Keysford Barn

DESIGN AND ACCESS STATEMENT

Revision A - May 2025

Planning Refusal 2024 | Case Officers Comments

Ground Floor Plan As Proposed

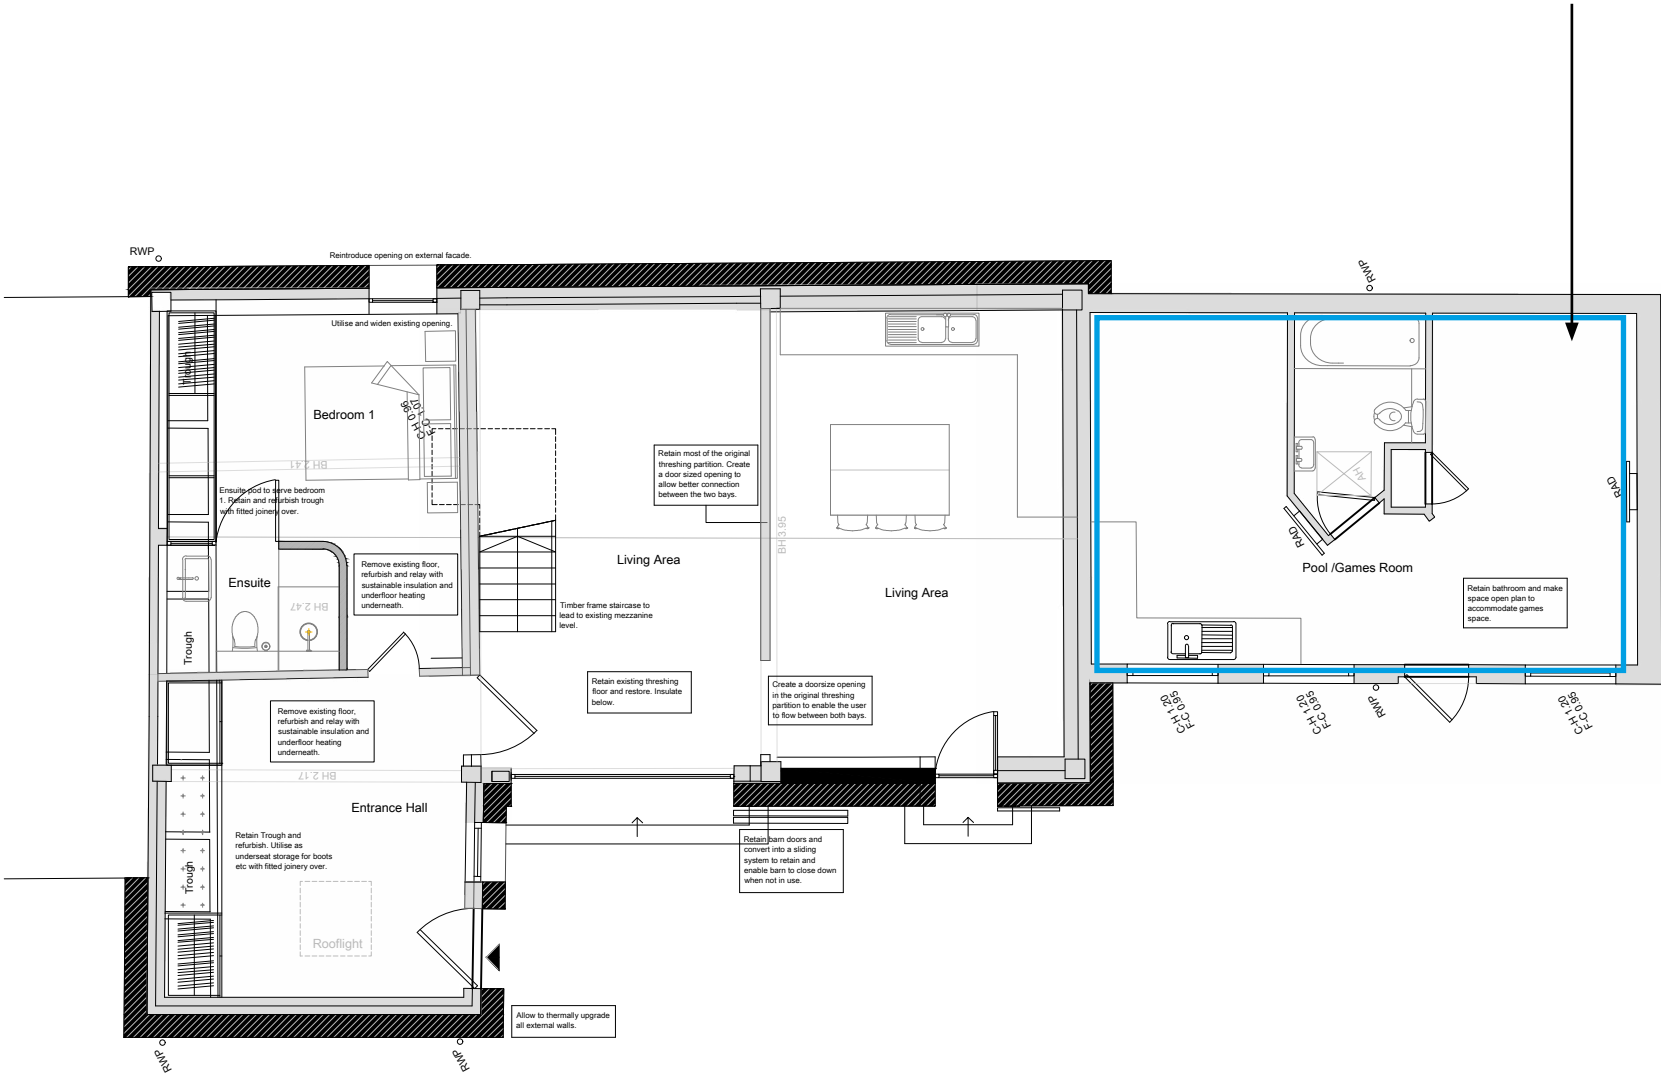
- Internally, although the proposed new mezzanine to the southern end of the building has been omitted, a second bedroom and a bathroom above the existing mezzanine floor remain part of the proposal. This entails enclosing this space, which will impact adversely on the internal volume of the main space within the barn, and on the current appreciation of the building's original form and dimensions. This aspect of the proposal should be omitted, and the space above the mezzanine retained as open onto the main volume of the barn- I would have no objection subject to detail to the introduction of stairs and a rail of an appropriate design which would allow the use of this raised area as part of the proposed living space. If further

enclosed space is required, the applicant could perhaps consider incorporating the existing adjacent annexe accommodation to the south of the barn, currently as I understand proposed as changing space for a swimming pool, into the scheme. Sectional drawings illustrating any works to the mezzanine area should be provided.

Noted. Following the report from AS Lewes, we now understand that the partition and floor to the mezzanine area is a later addition from the 20th century. With this in mind, we would like to retain the enclosed first floor bedroom and bathroom to accommodate more sleeping arrangements.

Thermal Upgrades

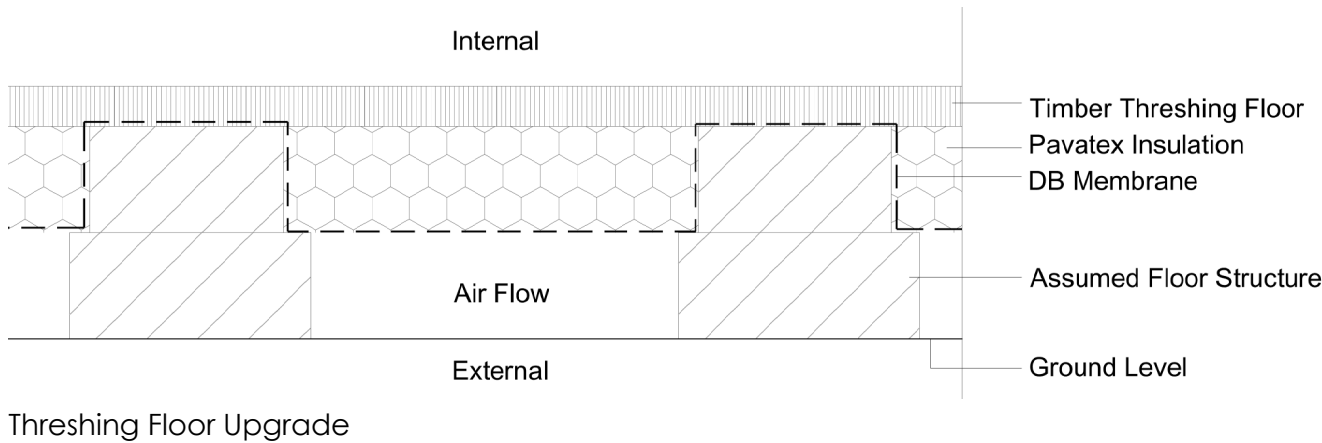
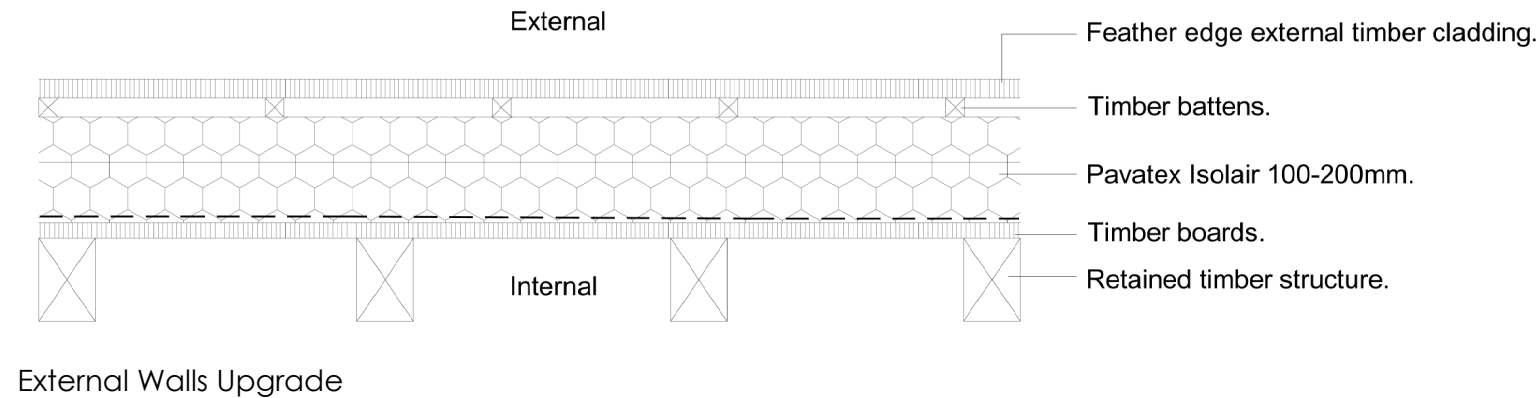
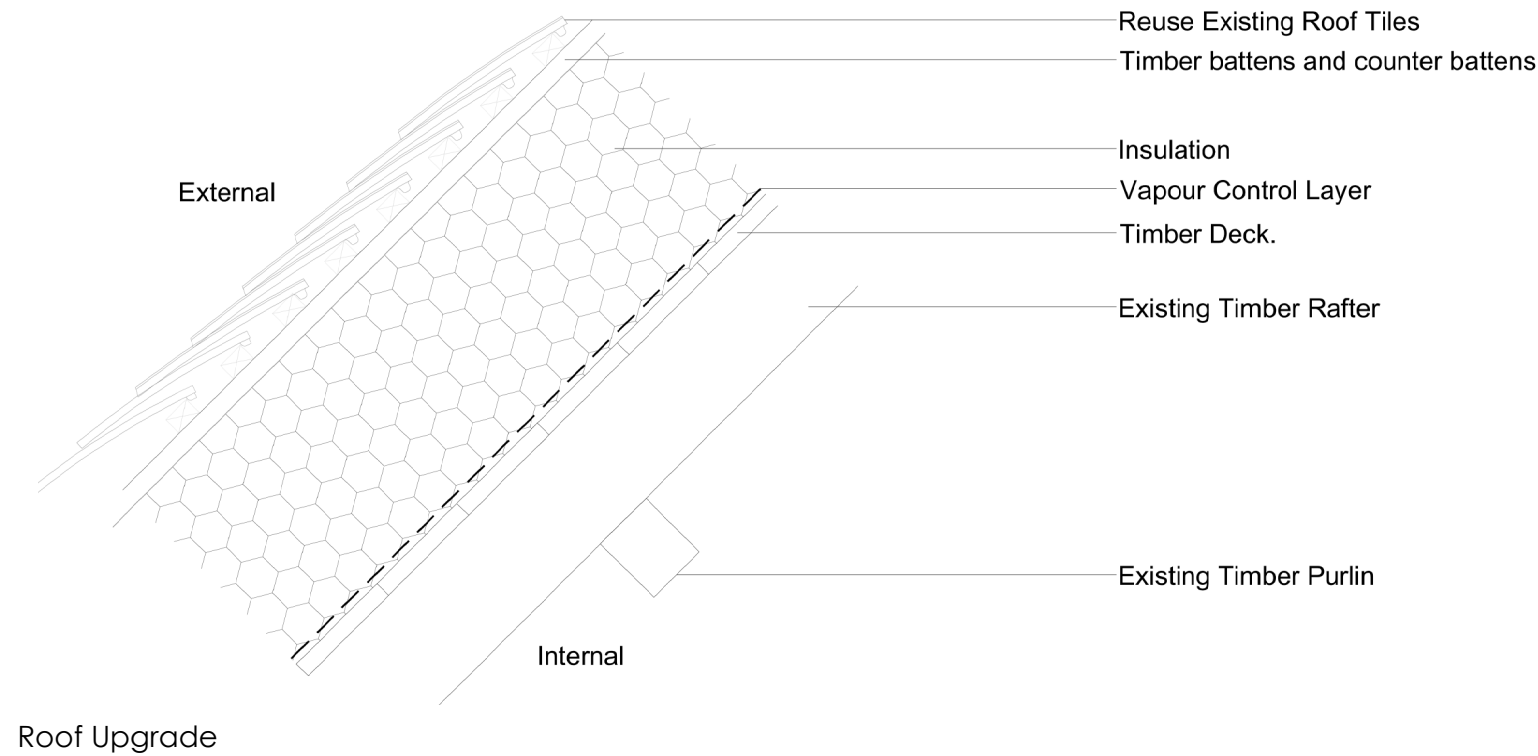
- Any formal application should include typical detail of the manner in which it is proposed to introduce insulation to walls, roof and floor of the building. This should be detailed with a view to retaining fabric and features of interest- for example the timber framing to the walls and roof of the building should remain exposed to view, as this is such a key component of the character of the building. Likewise the introduction of insulation beneath existing historic flooring will require careful consideration. Given the importance of this to the practicality of the scheme and its acceptability in listed building terms I would expect to see this detail as part of an application, rather than by condition.

Noted. We will have provided some ideas as how we would approach the upgrading of the floors, walls and roof and have indicated a thickness of 300mm to the external walls and as well as a raised ridge. With the hope of retaining the exposed timber frame internally.

In order to retain and expose the internal timber frame we must insulate the roof and walls externally. This will involve a deeper wall build up and a raised ridge. See details opposite and the proposed planning drawings for more detail.

Where possible we aim to use breathable insulating materials such as Pavatex and inditherm.

Insulating the floor may prove trickier given the historic nature of the threshing floor. However in order to restore and make this barn usable it is important that we insulate the floor. We are proposing to carefully lift the threshing floor and insert a D3 membrane between the floor structure where the Pavatex insulation can sit and then relay the threshing floor on top.
